MEMORANDUM

DATE: February 5, 2018
TO: Chairman and Members, Committee of Adjustment
FILE: A/165/16
ADDRESS: 2 Wildrose Crescent, Thornhill
HEARING DATE: February 7, 2018

Memorandum to the City of Markham Committee of Adjustment

File: A/165/16
Address: 2 Wildrose Crescent, Thornhill
Applicant: Eddie Leung
Hearing Date: Wednesday November 23, 2016

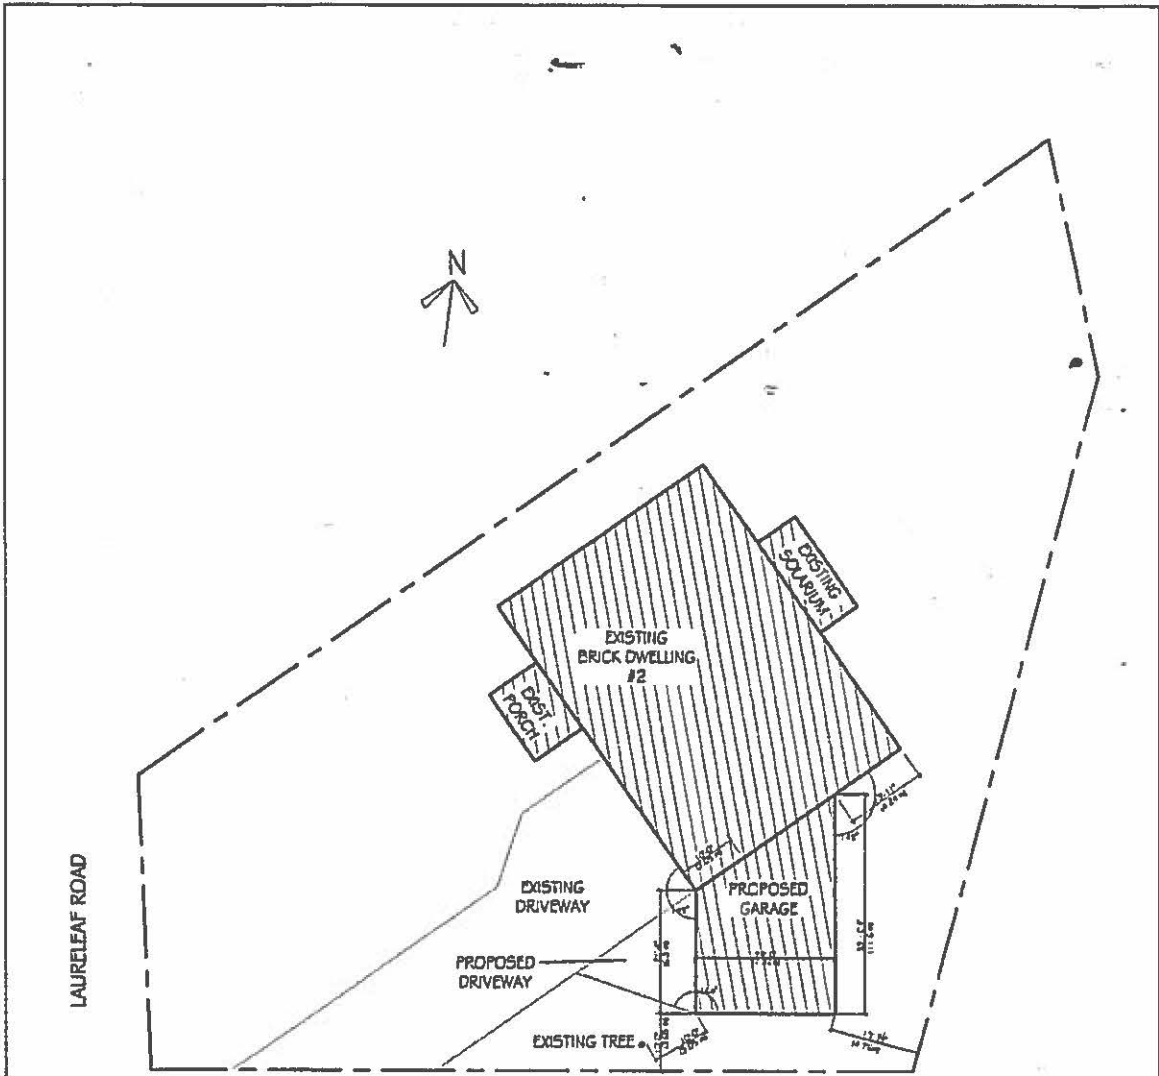
The applicant is requesting to permit a minimum flankage yard setback of 9.75 ft. (2.97 m); whereas a minimum flankage setback of 12.00 ft. (3.65 m) or ½ the height of the dwelling, whichever is greater, is required. The Building Department has confirmed that the 12.0 ft. (3.65 m) measurement is greater than ½ the height of the dwelling. The intent of the minimum flankage yard setback requirement in the zoning by-law is to minimize the visual impact of buildings and structures on the streetscape. This is equivalent to an 18 percent reduction to the flankage side yard setback, and will result in the side wall of the proposed garage projecting approximately 4.5 m (15.0 ft.) in front of the existing dwellings to the east.

The applicant is requesting to permit a maximum garage width of 11.76 m (38.58 ft.), whereas a maximum of 7.70 metres (25.26 ft.) is permitted on lots having a frontage less than 18.30 m (60.0 ft.). The proposed garage addition represents a 52 percent increase to the maximum permitted garage width and will result in a building form that is not compatible with neighbouring properties.

It is the opinion of the Planning staff that requested variances to permit a reduced flankage side yard setback of 9.75 ft. (2.97 m) and an increased garage width 11.76 m (38.58 ft.) do not meet the 4 tests of the Planning Act. The variances requested will allow for a building that will be out of character with other homes in the neighbourhood and which does not meet the general intent of the zoning by-law, and therefore, cannot be supported.

The applicant has revised the proposal to reduce the requested maximum garage width from 11.76 m (38.58 ft.) to 9.7 m (31.82 ft.). In addition, the previous variance request to permit a reduced minimum flankage side yard setback of 9.75 ft. (2.97 m) is no longer required.

The Committee should satisfy themselves as to the appropriateness of the revised application to permit a maximum garage width of 9.7 m (31.82 ft.). Staff recommends that the Committee consider public input in reaching a decision.
